RE: Development Application for 6014 45 Avenue

Thank you for giving the Waskasoo Community Association Board the opportunity to respond to the development application for Parkland CLASS at 6014 45 Avenue.

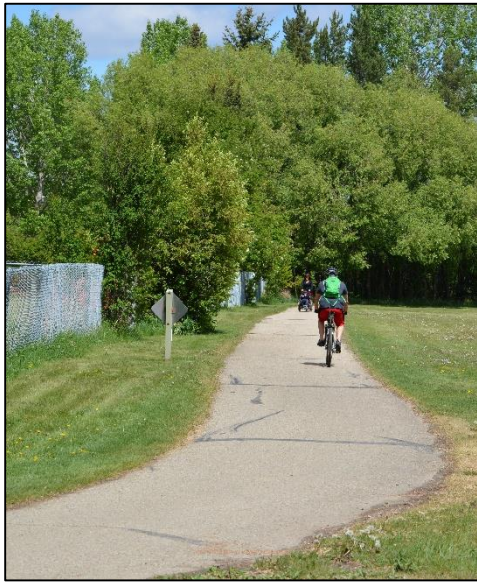
While Lot 4 is already fenced around the outer perimeter, the addition of more fencing will add to the restrictions on wildlife movement. These fences (often running bizarrely parallel only a few feet apart)

will have two results on area wildlife. First they will create entrapment areas (for example the area above the diamonds and now fenced on four sides, the MR area to the north which will be double fenced running east and west, the area between the proposed parking lot and the playground which will be fenced on three sides, the area behind the administration building which will be completely enclosed, and the area along the trail system which will also be double fenced.) Chris Olsen, Professional Wildlife Biologist and Waskasoo resident states that as a result of all of

We request that other than the fencing surrounding the shop and that which keeps playground users from entering traffic areas, all of the fencing around this property should be eliminated. It will create safety hazards for people and wildlife. The fencing that has been installed on the south side of the access road to separate Lot 4 from the Gateway School could easily be replaced with landscaping. This property is the grounds for an administration building not a school yard. Similar use buildings in the city do not have extensive fencing, for example Family Social Services of Central Alberta, Catholic Social Services, or the Red Deer Public School Board downtown offices.
